Access Compliance Report

Public Rights-of-Way

(Curb Ramps)

Intersection ID: 47465	Main Street: DOMINION_VILLAGE_DR	Cross Street: DOMINION_GREEN_DR	Location: E
ADA ID: B42A460DDD96	Ramp Type: PerpDiag	Initial Pass/Fail: Pass	Overall Compliance: No
		Severity Score: 7.75

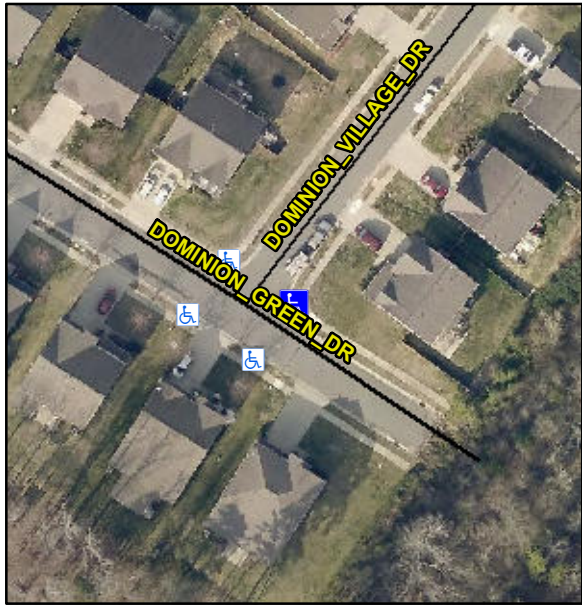
Codes/Mitigation Info/Possible Solution			Field Measurements/Component Compliance					
	Possible Solutions:		Compliance	Description	Data	Compliance	Description	Data
	Remove & Replace Curb Ramp With Two New Directional Ramps or Equivalent. Remove & Replace Gutter.		N/A	Ramp Length (in)	50.0	Yes	Ramp Slope (%)	7.2
			Yes	Ramp Width (in)	48.0	No	Ramp XSlope (%)	4.3
			N/A	Flare Type LT	Sloped	N/A	Flare Type RT	N/A
			N/A	Flare Slope LT (%)	8.5	Yes	Flare Slope RT (%)	2.4
			N/A	Flare Traversable LT?	Yes	N/A	Flare Traversable RT?	Yes
			No	Landing Length (in)	45.0	Yes	DWS Provided?	Yes
			Yes	Landing Width (in)	48.0	Yes	DWS Contrast?	Yes
			Yes	Landing Slope (%)	0.2	Yes	DWS Length (in)	24.0
			No	Landing X Slope (%)	4.8	Yes	DWS Full Width?	Yes
Surveyor Notes:			N/A	Landing Curb? (Y/N)	No	No	DWS Offset (in)	8.0
PROW/ADA:			N/A	Shared Landing?	No			
Not Found, R304.5.3, R304.2.1, R305.2, R302.7.2			Yes	Gutter Ponding?	No	Yes	Gutter Slope (%)	0.4

No	Gutter Lip Ht (in)	0.5	No	Gutter X Slope (%)	3.3
			N/A	Painted X Walk1?	No	N/A	Painted X Walk2?	No
				X Walk 1 Direction	To NW		X Walk 2 Direction	To SW
			N/A	X Walk 1 Width (in)	N/A	N/A	X Walk 2 Width (in)	N/A
				X Walk 1 Slope (%)	5.7		X Walk 2 Slope (%)	1.3
				X Walk 1 X Slope (%)	1.9		X Walk 2 X Slope (%)	5.3
			N/A	Ramp inside XWalk1?	N/A	N/A	Ramp inside XWalk2?	N/A
				Road Slope (%)	3.0	N/A	Clear Space?	Yes
				Road X Slope (%)	4.5	N/A	Clear Space to XWalk (in)	N/A
			Yes	Any Obstructions?	No	Yes	Storm Grate/Utility Hazard?	No
				Obstruction Type			Storm Grate/Utility Type	
						N/A		N/A
						Yes	Surface Condition? (G/P)	Good
								</
